APPROVING AMENDMENT TO THE CONCEPTUAL DEVELOPMENT PLAN FOR THE SOUTHRIDGE MALL TO AMEND THE DESIGN OF THE PROPOSED UNITY POINT MEDICAL CLINIC AT 6520 SE 14th STREET

**Amended Conceptual Development Plan  
for the Unity Point Clinic at 6520 SE 14th Street**  
an amendment to the Conceptual Development Plan  
for the overall Southridge Mall project area

**UNITY POINT SOUTHGLEN**  
 6520 SE 14TH STREET  
 DES MOINES, IOWA  
 09-12-2017

④ **WEST ELEVATION**  
1/8" = 1'-0"

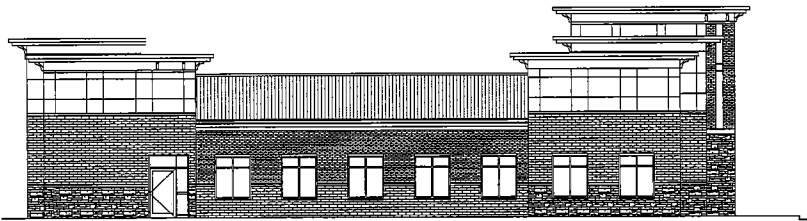
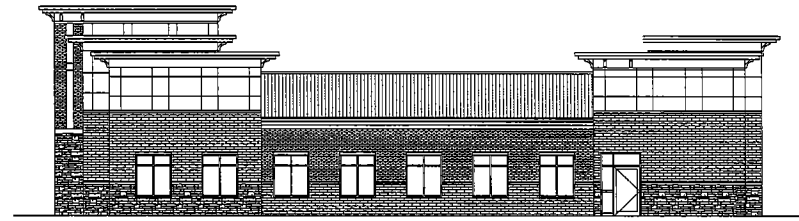
- Take a look and provide more detail of the transitions between building materials, particularly between the brick and the EIFS material on the tower features above the roof line.
- Bring down the "proportionality" of the upper floor elements. The building is trying to appear as 2 stories, but the elements are decorative only.
- Study if window glazing could be added to the upper floor elements in lieu of solid materials.
- Try reducing the slope of the main portion of the roof, which could cause the upper floor elements to be reduced in height and stature.

MOVED by \_\_\_\_\_ to adopt, subject to the Amended Conceptual Development Plan being first amended to address the concerns raised by the Urban Design Review Board, and to the Economic Development Director approving the amended Plan as having adequately addressed the Board's concerns.
